ATTACHMENT 1 – Council Submission

SSD-76555711 - 3-5 Help Street, Chatswood

Figure 2: Extract from Visual Impact Assessment (Appendix P) – when viewed from Chatswood Concourse facing north-west

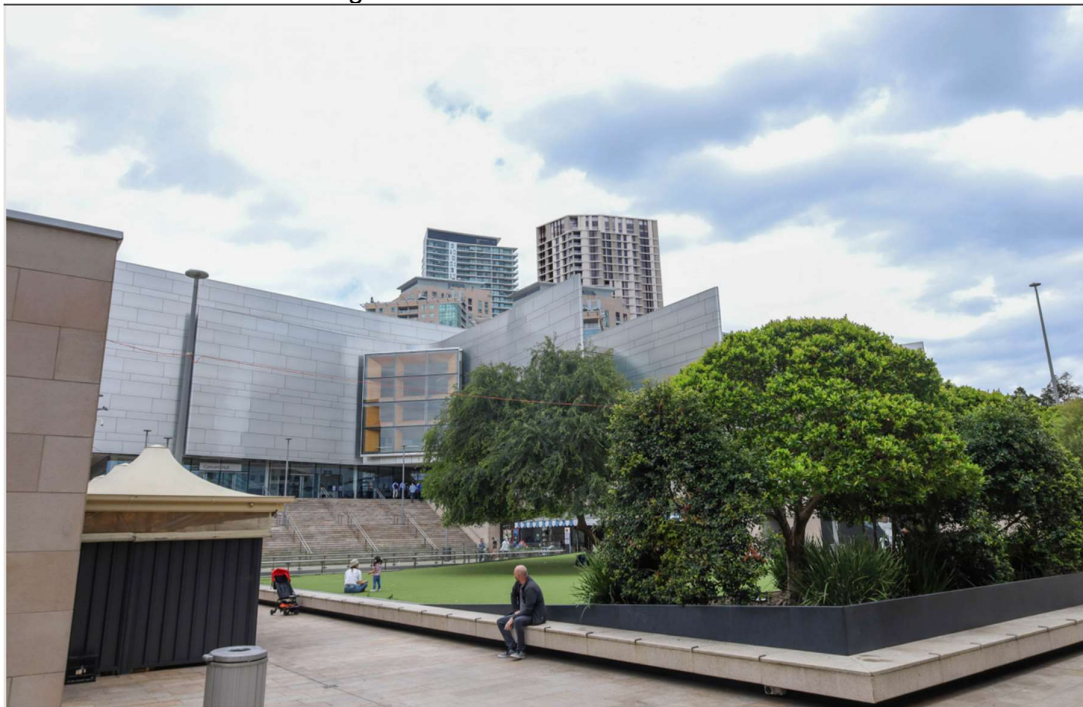
Having regard to the circumstances of this site and its location on the CBD boundary, Council is supportive of a shop top housing development consistent with WLEP 2012 controls. Whilst Council acknowledges that some increase over the WLEP height of 90m may be accommodated with minimal additional impact, Council requests consideration be given to some reduction in the proposed height to reduce the visual impact when viewed from Chatswood Concourse (when facing north-west) and Chatswood Oval (when facing north).

As seen from Figure 2 and 3 above, a minor reduction in the proposed height would still allow a significant amount of housing to be delivered, while improving modulation in the presentation of the CBD, particularly when viewed from Chatswood Concourse and Beauchamp Park. This is an important consideration as there will be future development at similar heights, and providing this modulation is necessary to improve the visual impact.

A nuanced approach to the Housing SEPP 30% bonus uplift is sought, with the proposed additional height in this location considered inappropriate based on bulk and scale impacts on the CBD boundary to the adjacent low density residential conservation area, and undermines recent strategic planning and community faith in the NSW planning system. The heights in this location have recently been substantially increased and indeed maximised. Whilst Council does not refuse any increase over the WLEP height of 90m, Council requests the proposal to be reduced in height to mitigate impacts to adjoining development and the conservation area to the north-east, whilst providing improved modulation when viewed from the surrounding locality.
